FAQ Number 07-0039 FAQ Revision 2

FAQ Title Lessons Learned – NEI 04-02 B-2 Table

Plant: Harris Date: September 12, 2008

The purpose of this FAQ is to provide updates to NEI 04-02 to reflect lessons learned from pilot plant activities, NFPA 805 task force meetings, and NRC reviews and discussions.

Figure XX – Summary of Nuclear Safety Methodology Review Process

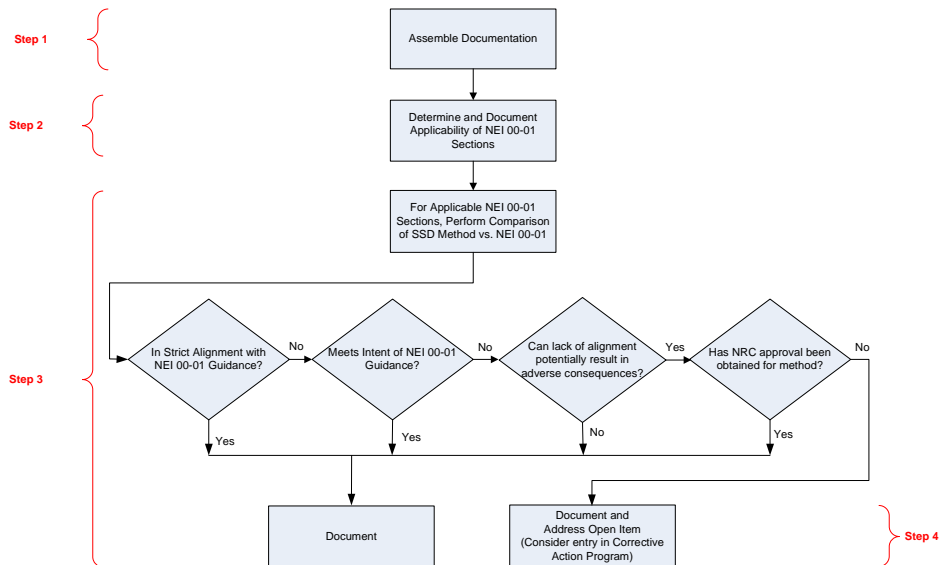
Tables B-2 and B-3 of this Appendix outline a recommended method to review the acceptability of a program for transition by examining the basic components of a nuclear safety capability assessment. These worksheets organize the transition of the ‘pre-transitional safe shutdown analysis’ to the ‘nuclear safety analysis’ as follows:

The review should be conducted against the methodology provided in NEI 00-01 Chapter 3, “Deterministic Methodology”. This review is intended to ensure that the transitioning nuclear safety analysis meets basic established criteria for identification and analysis of equipment and cables. Exceptions and clarifications identified during the transition review should be documented in order to provide a well-established baseline for future changes.

Figure 4-3 - Fire Area by Fire Area Transition Process (Simplified)

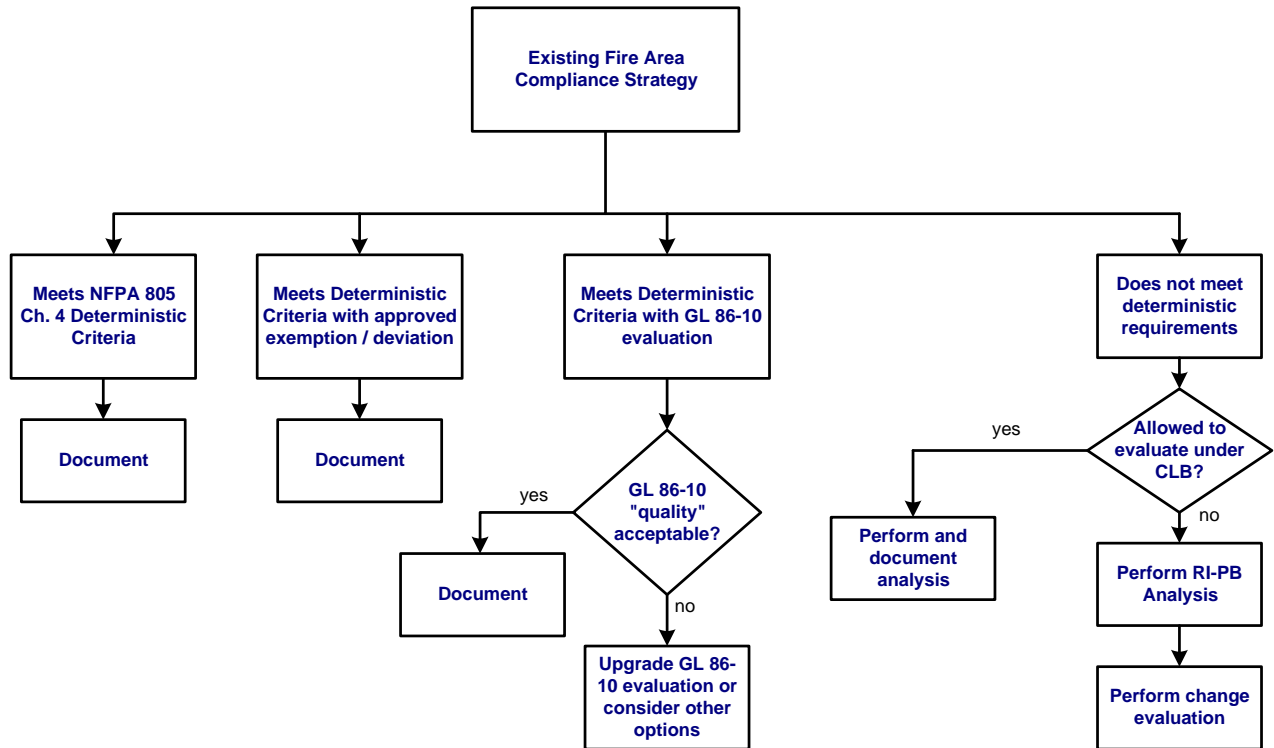
A simplified flowchart of the fire area by fire area transition review is provided as Figure 4-3 below.

The fire area by fire area review determines whether the CLB is intact and documented adequately to support the transition. The review is intended to identify and document how each fire area:

Figure YY – Summary of Fire Area-by-Fire Area Review

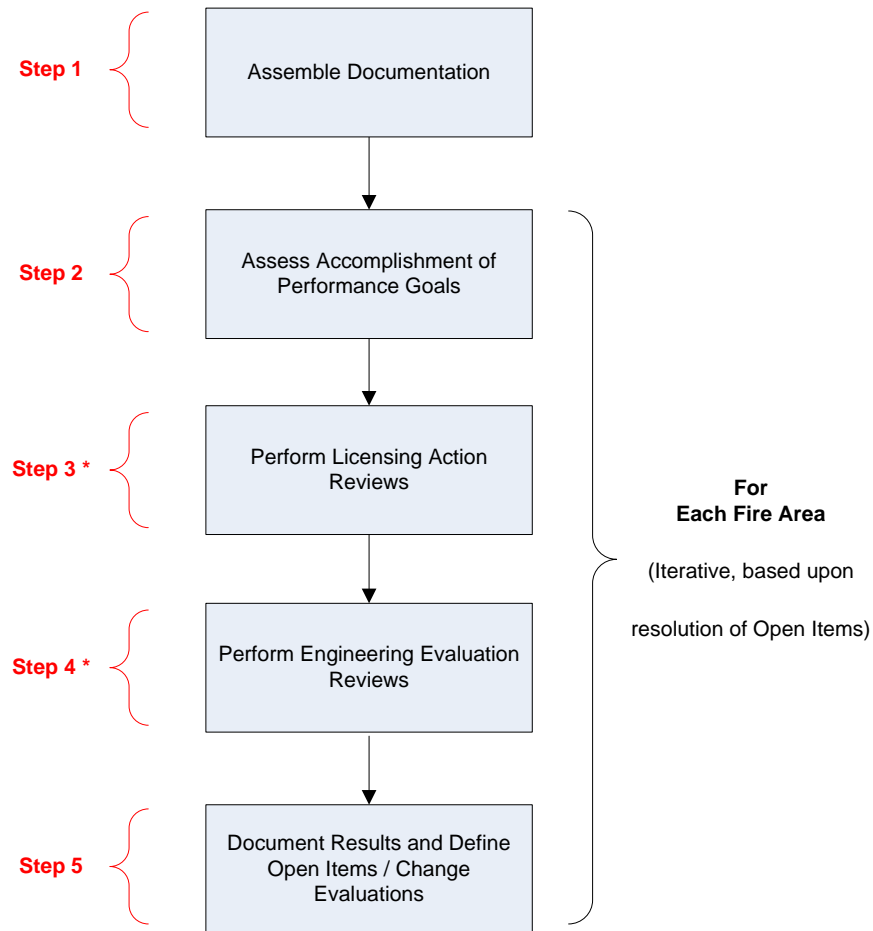
A summary level diagram of the steps to be used in developing the Nuclear Safety Fire Area-by-Fire Area transition review is shown as Figure XX.

* - These steps may be performed early in the process (e.g., prior to Step 1) for project efficiency, if available resources and program documentation facilitate a review before the performance goal assessment.
